Docket Item # 3 BAR CASE # 2016-0160

BAR Meeting December 20, 2017

**ISSUE:** Certificate of Appropriateness - Alterations

**LOCATION:** 420 South Lee Street

XZ GATES

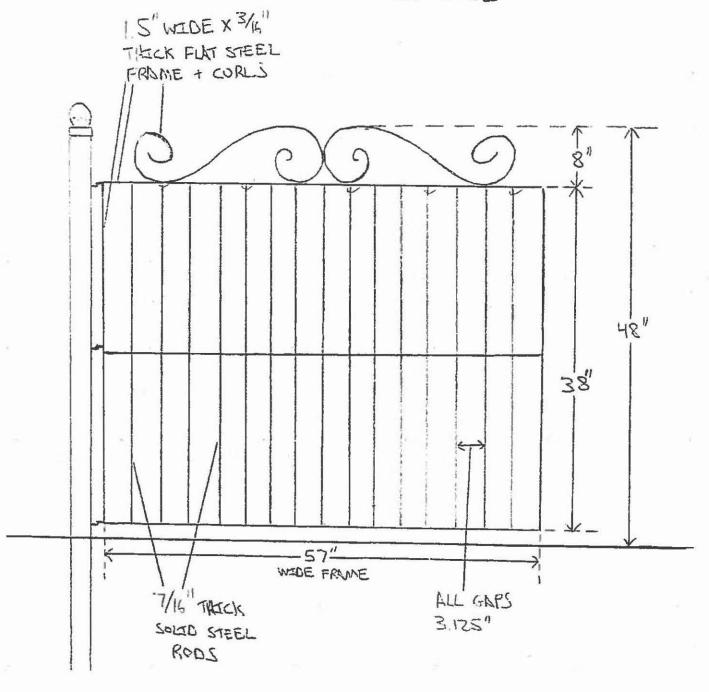
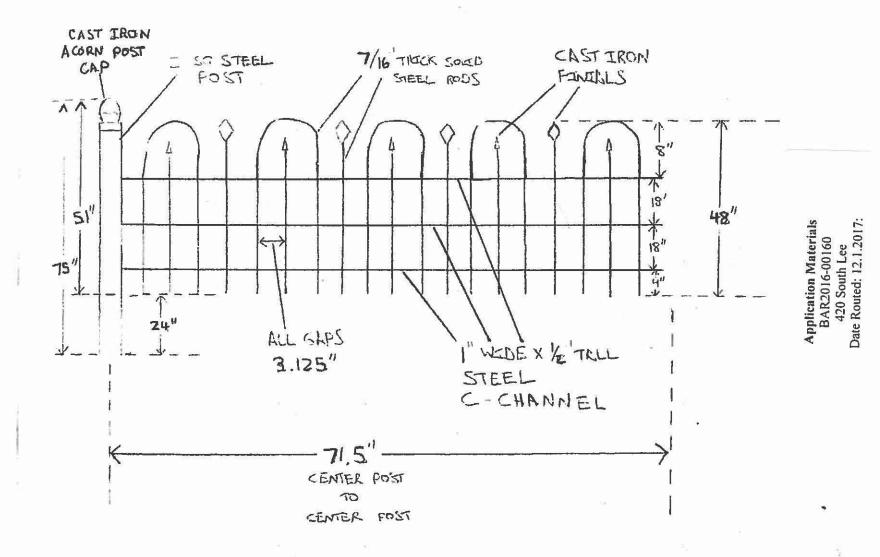
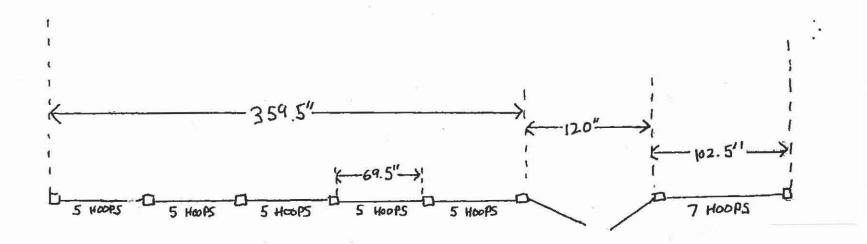
- 1. The double gate may be no wider than 6' in total;
- 2. Either relocate the reduced width double gate to align with street facing front door or add a second gate that aligns with the front door;
- 3. Per City regulations, gates cannot swing into the public right-of-way;
- 4. Call Alexandria Archaeology immediately (703-838-4399) if any buried structural remains (wall foundations, wells, privies, cisterns, etc.) or concentrations of artifacts are discovered during development. Work must cease in the area of the discovery until a City archaeologist comes to the site and records the finds.
- 5. The applicant shall not allow any metal detection or other artifact collection to be conducted on the property, unless authorized by Alexandria Archaeology.

The former pedestrian gate that aligned with the walk and the front door of the dwelling is to the left and outside of the image in the 1930s photo and the applicant does not propose to install another gate in that location. While staff can support a double gate that is appropriately scaled (no greater than six feet in total width for both gates), staff strongly recommends that a single gate also be installed that is aligned with the main entrance to the building on the north side of the property and does not support the applicant's request to remove the existing walkway. It is unusual and disruptive to the historic streetscape for an entry gate to not visually relate to the historic entry to the property. The entrance to the property has been located on the north side of the lot since 1871. As the property frontage is nearly 49 feet in width, staff finds that a single gate aligned with the house entrance and a small pair of gates at the southern part of the property is appropriate. Any fence or gate must be installed entirely on the subject property and gates may not swing over the public right-of-way, in accordance with City regulations.
